**APPLICATION FOR PERMISSION
UNDER SECTION 16 OF
THE TOWN PLANNING ORDINANCE
(CAP. 131)**

Application No. 申請編號	(For Official Use Only) (請勿填寫此欄)		
Location/address 位置/地址	Lots 788 (Part), 790 (Part), 793, 794 and 801RP in D.D. 381 and Adjoining Government Land, Tuen Mun, New Territories		
Site area 地盤面積	<div style="display: flex; justify-content: space-between;"> 4,432 sq. m 平方米 <input checked="" type="checkbox"/> About 約 </div> <div style="display: flex; justify-content: space-between;"> (includes Government land of 包括政府土地 677 sq. m 平方米 <input checked="" type="checkbox"/> About 約) </div>		
Plan 圖則	Draft Tuen Mun Outline Zoning Plan No. S/TM/38		
Zoning 地帶	"Open Space" ("O") and "Government, Institution or Community" ("G/IC")		
Applied use/ development 申請用途/發展	"Proposed Temporary Place of Recreation, Sports or Culture (Barbecue Area and ancillary Electric Kiddie Ride) and Temporary Holiday Camp (Private Tent Camping Ground)" for a Period of 6 Years

Comments	Responses
a.	Plan 3a is found missing. Also, please provide the photos of ancillary kiddie ride;	Plan 3a is attached. The applicant will not provide any kiddie ride. The location is replaced by play activity area.

1:750 (A3)	Drainage Proposal Lot 788(part), 790(part), 793, 794 & 801 RP in D.D. 381 and Adjoining Government Land Tuen Mun, New Territories	Goldrich Planners & Surveyors Ltd.
October 2024		Plan 5.1 (P 22015)

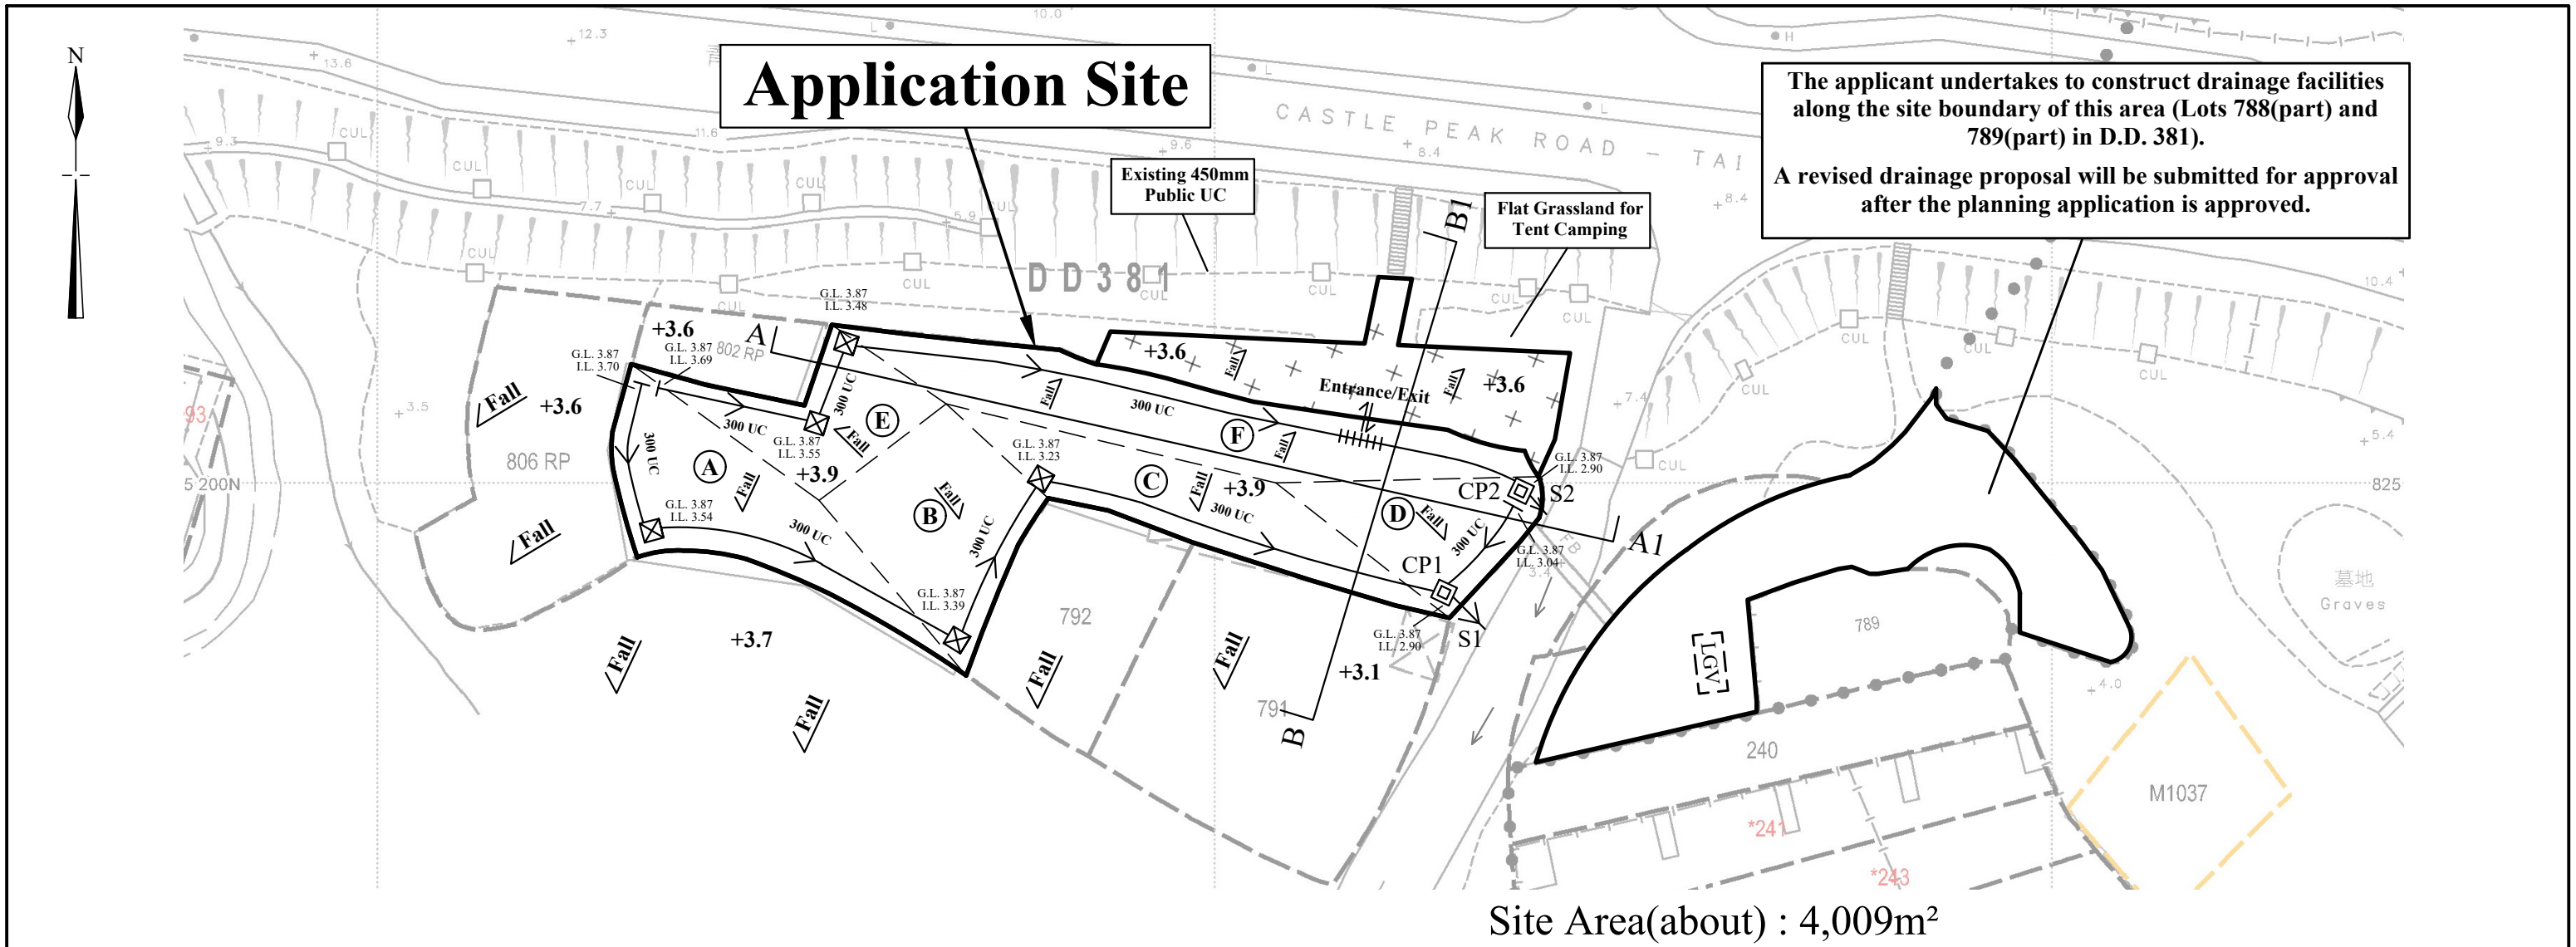
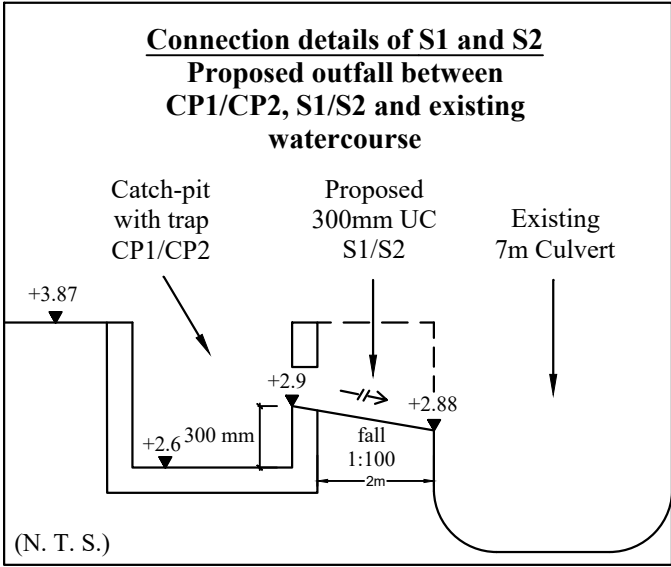
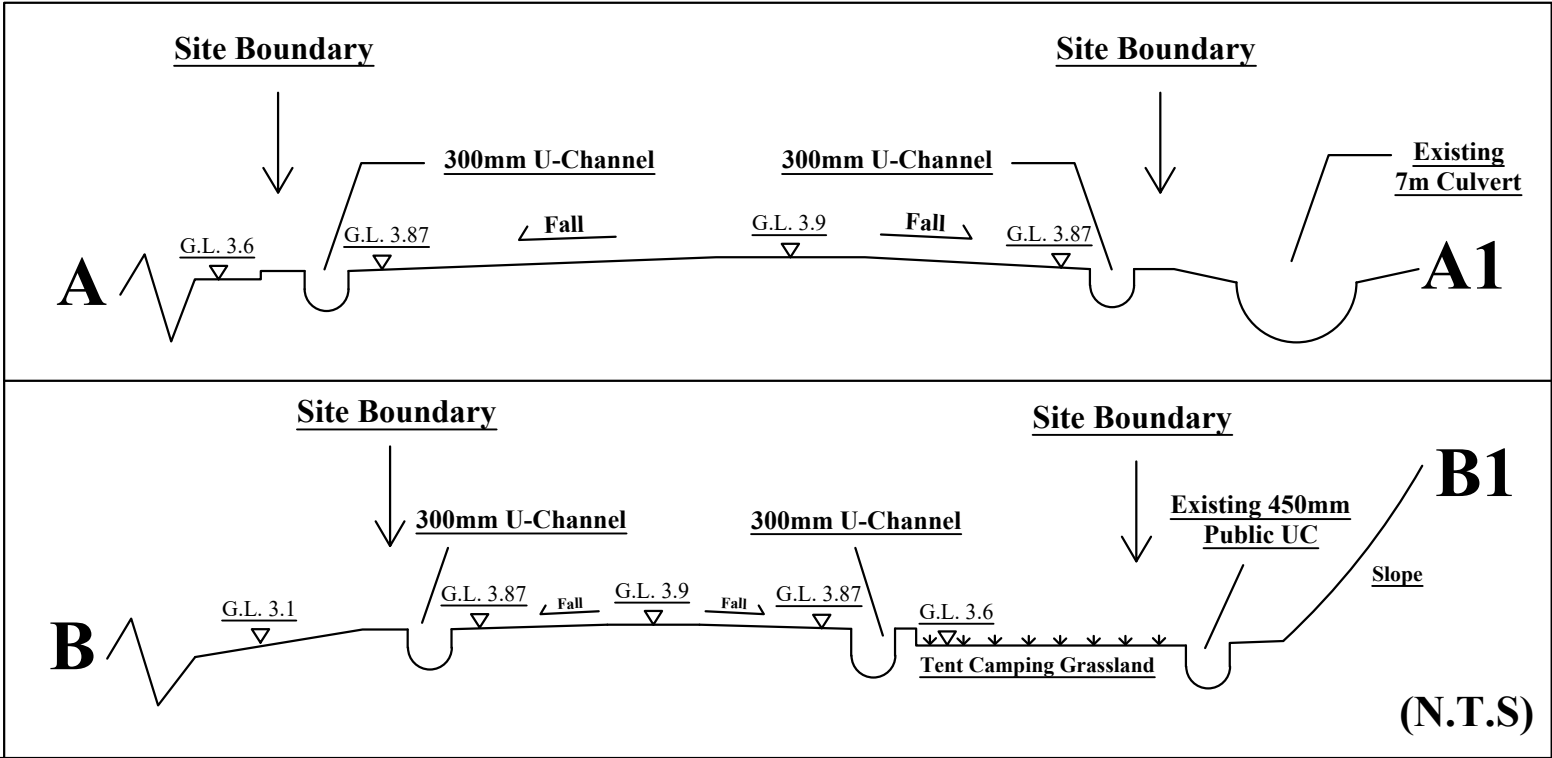
Comments	Responses
1.	The catchment plan and proposed drainage plan are missing. Please provide.	The catchment plan and proposed drainage plan are attached (Plan 5a).
